**MarathonNorco Aerospace, Inc.  
8301 Imperial Drive  
Waco, Texas 76712-6588**

# **SERVICE BULLETIN**

**SB-SS112-52-1**

**Subject: Product Improvement – Escape Slide/Raft – Add Positive Lock  
to Packboard Latch**

Figure 1. Base Plate to Handle Clearance Measurement Location

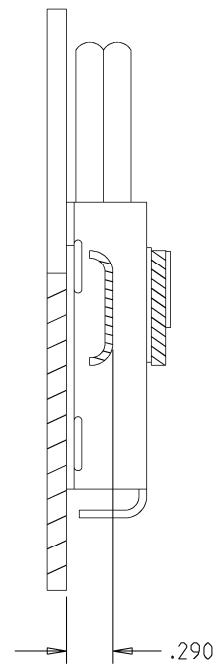
- a. Orient the SS112A1 or SS112A11 assembly so that it can be viewed in the locked position.
- b. Ensure that the release arm is in the locked position.
- c. Measure the clearance between the handle and the base attachment plate of the assembly at the edge of the base plate as shown in Figure 1.

- d. If the nominal measurement exceeds 0.290 inches then the part must be returned to the manufacturer for rework.
- e. If the measurement is 0.290 inches or less then rework following the procedure outlined in Part 3 of this section.

Figure 2: Orientation of the Base Plate Block Spring SSM112-11A-46

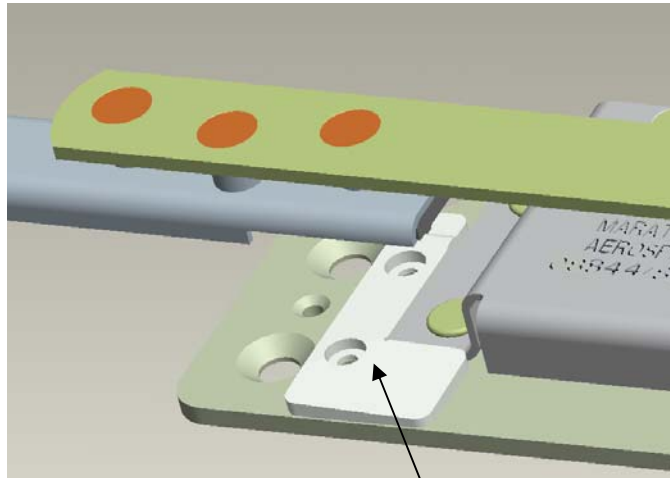
- a. Rotate the handle from the locked position to the unlocked position.
- b. Align the base plate Block Spring as shown in Figure 2 insuring that the part fits tightly to the corner of the mating part.

Figure 3: Interface holes in Base Plate

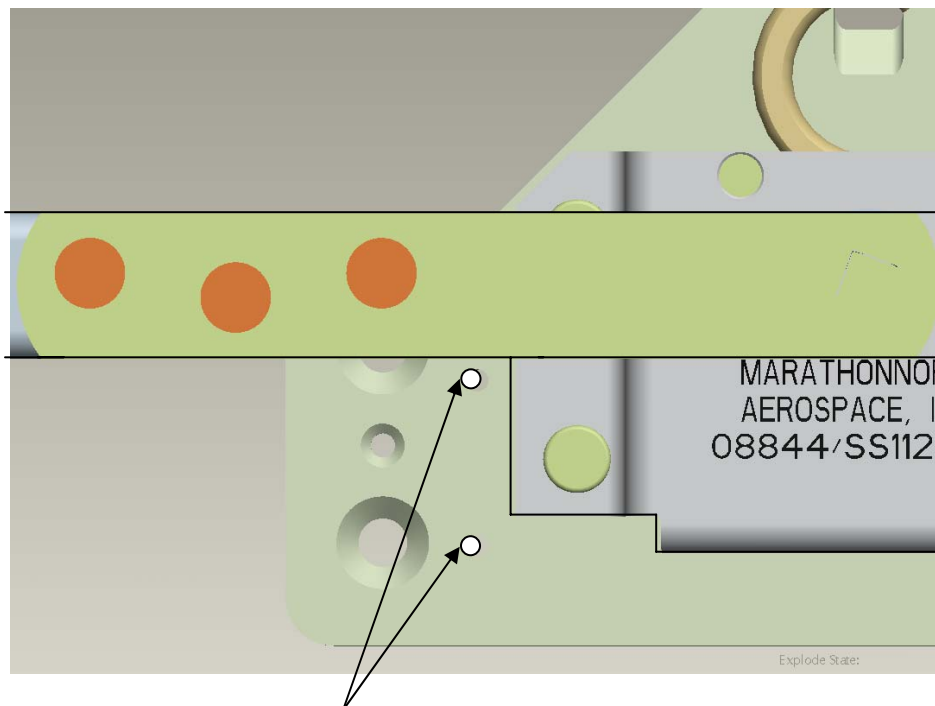
- c. Mark the holes while the Block Spring is in place then remove it and drill the .098 diameter interface holes at the locations shown in Figure 3.

- d. Open pilot holes shown in Figure 3 to .1120, tap using 40 UNC-2A tap and debur.
- e. Apply adhesive to the back of the base plate side of the base plate Block Spring per Standard Overhaul Practices Manual (SOPM) 20-50-12 Type 117 or Type 71. BAC5010 adhesive, suggested use Loctite Hysol 608.

Figure 4: Installation of Screws

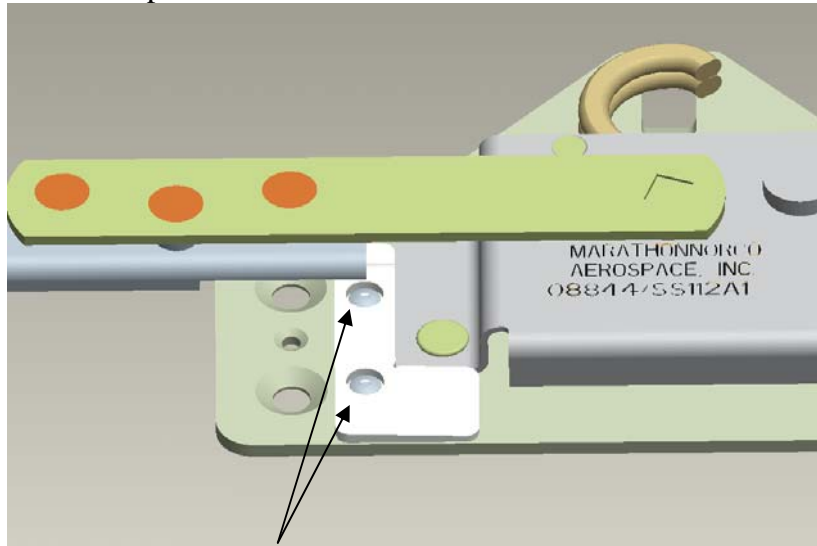
- f. Install base plate Block Spring in the orientation shown in Figure 4 using the 2 screws 63C0112-20 provided in the rework kit.

Figure 5: Location of Insert Under Handle, P/N SSM112-11A-48

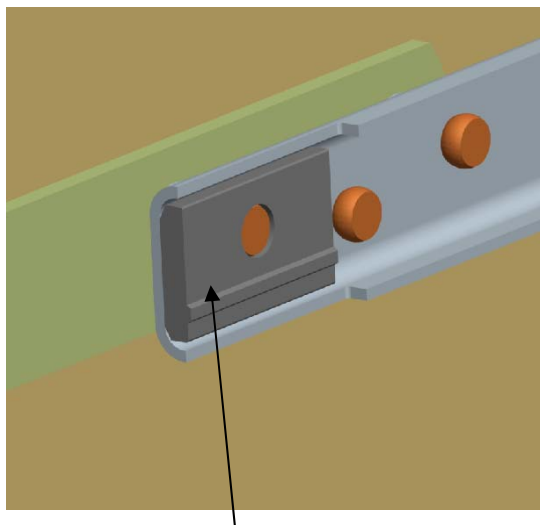
- g. Locate the handle Insert as shown in Figure 5.

- h. Apply adhesive to the Insert per SOPM 20-50-12 Type 117 or Type 71. Use sufficient adhesive to obtain squeeze-out between Insert, handle flanges and rivet head.
- i. Press the Insert with adhesive into the handle as shown in Figure 5 and clamp securely until adhesive is set up and dry.
1. Insert will only fit as shown in Figure 5.
- j. Allow the adhesive to dry then remove the clamp from the assembly.
1. Cure / Dry time is specified by the adhesive manufacturer

Figure 6: Exploded View of the Updated Assembly

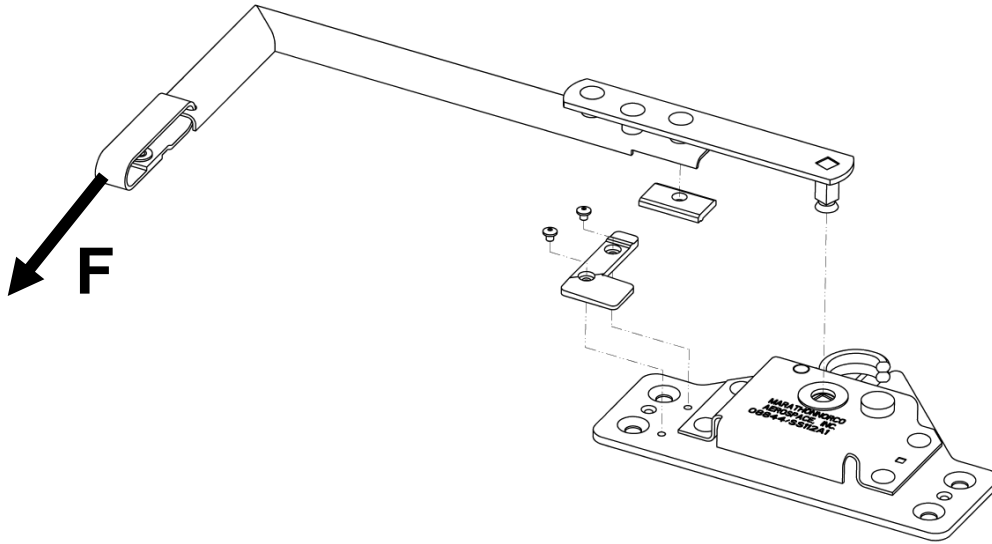
- k. Operate the handle to ensure that all of the components are securely in place and that the handle will not operate unless pulled open with a force of 1.5 lbs or greater (force applied at the webbed loop at the end of the handle – as shown in Figure 6). Handles that do not meet the 1.5 lbs requirement must be returned to the manufacturer for rework.
- l. Reference Figure 6 for exploded view of installation.
